WHITE TAIL RIDGE PH.IV

OAKSIDE C – 2022

**Re: Proposed Single Family Dwelling, 119 Frank Fisher Crescent, Lot # 139 White Tail Ridge, Almonte,  
Kollaard Associates File # 230020**

With regard to structural issues only, Kollaard Associates has reviewed the following drawings:

RIGHT SIDE ELEVATION C

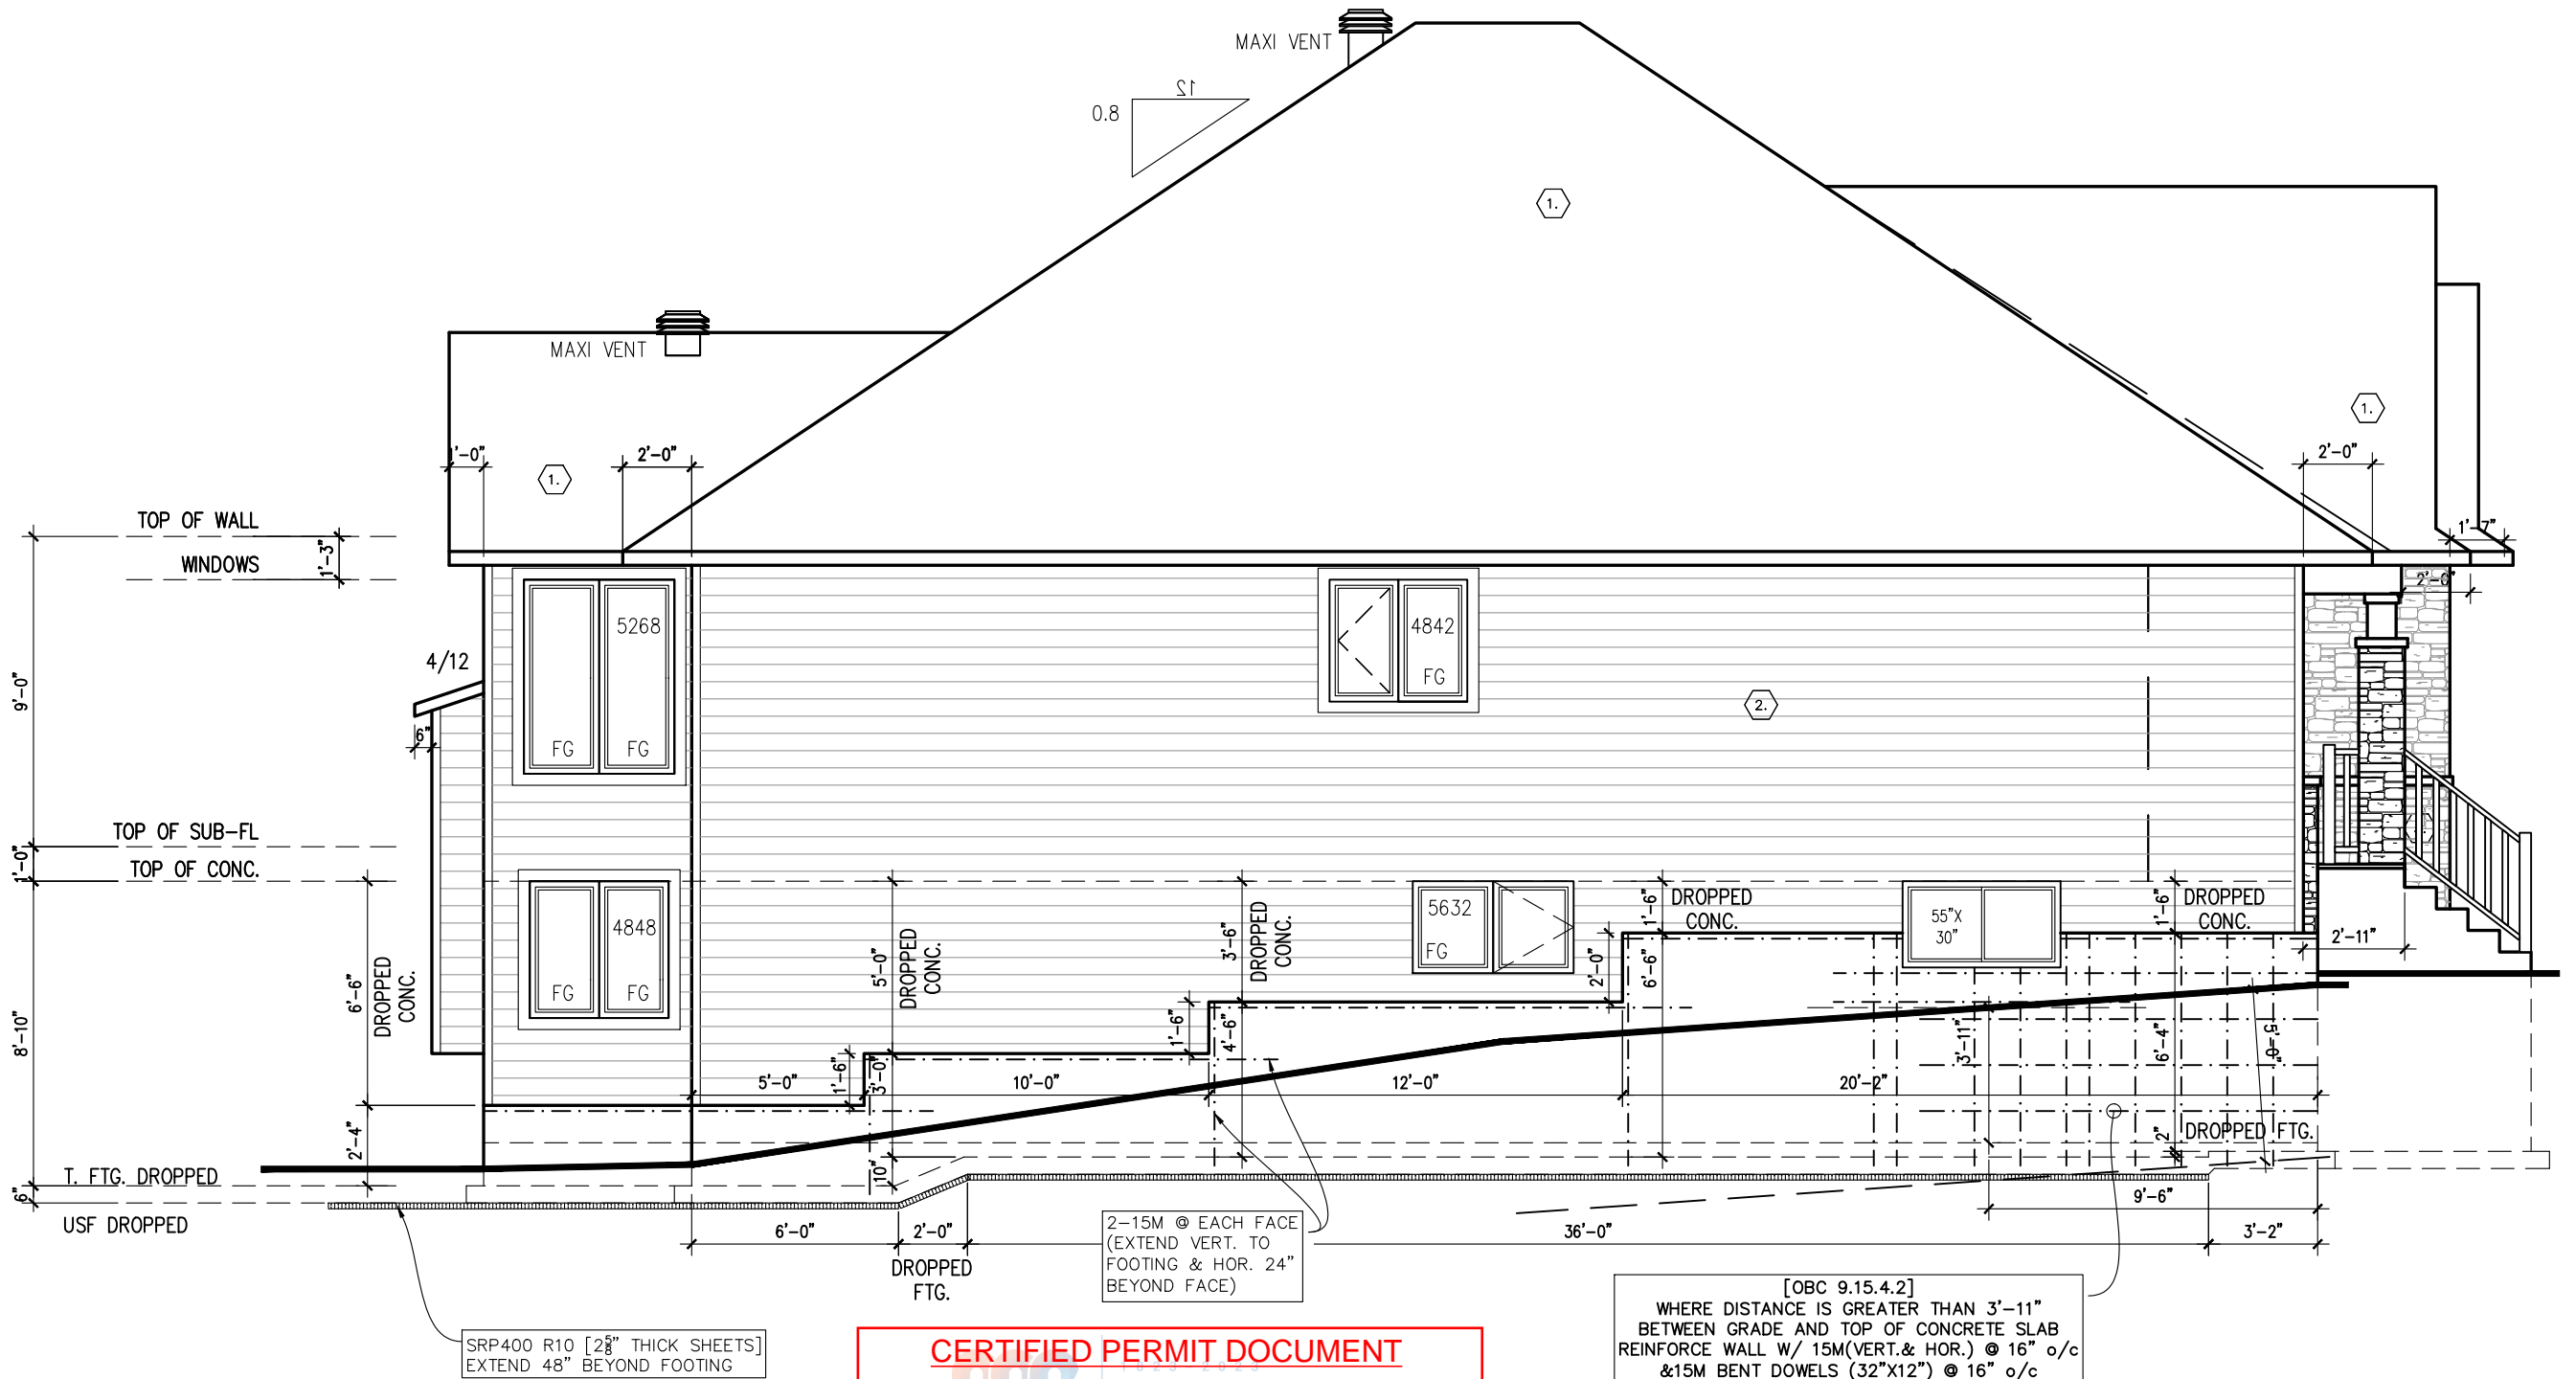
8. Where the grade difference between the basement slab and the exterior finished grade exceeds 3'-11" along the left side, the proposed foundation reinforcement noted on Phoenix Homes Pages # 5, 7 and 8 is adequate to withstand the lateral earth pressures.
